**Noise From Front of Vehicle –
Cooling Duct Vibration –
Repair Procedure**MODEL 1998 MY-ON
V8 XJ Series

VIN 812256-ON

ILLUSTRATION 1

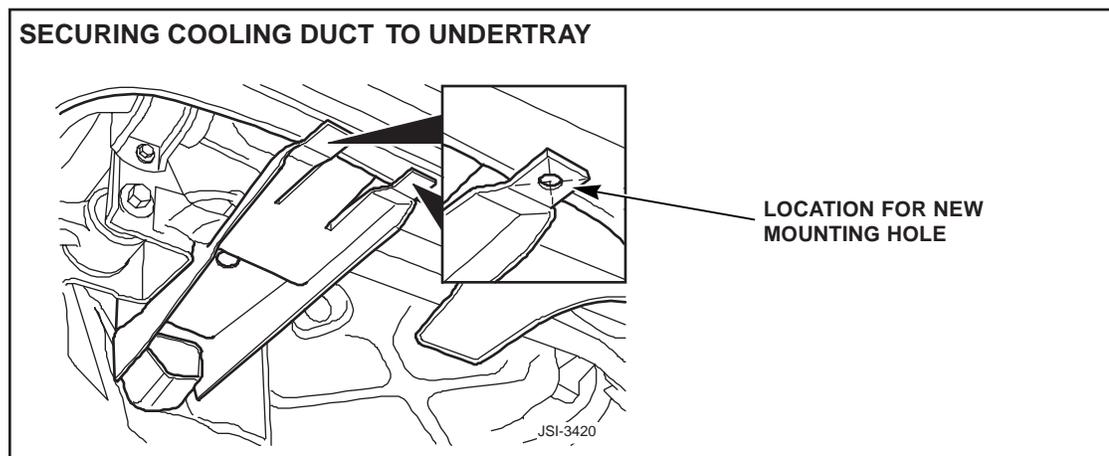
Some 1998 MY V8 XJ Series vehicles may experience a noise, when the vehicle is driven at speeds above 60 mph, (120 km/h). The noise has been identified as being caused by the vibration of the leading edge of the generator cooling duct, where it engages the undertray.

The cooling duct has three fingers on the forward edge which locate on the rear edge of the undertray. The center finger fits over the tray and the outer two fingers fit under the tray.

1. Raise the vehicle on a lift.
2. With the cooling duct and the undertray in position, mark the centers of the overlapping portion of the outer two fingers (Illustration 1).
3. Obtain two plastic rivets (part no. KRA 106001).

4. Drill two holes through the undertray and the duct at the centers (Illustration 1), large enough to provide clearance for the rivets.
5. Install the rivets to secure the duct in position.
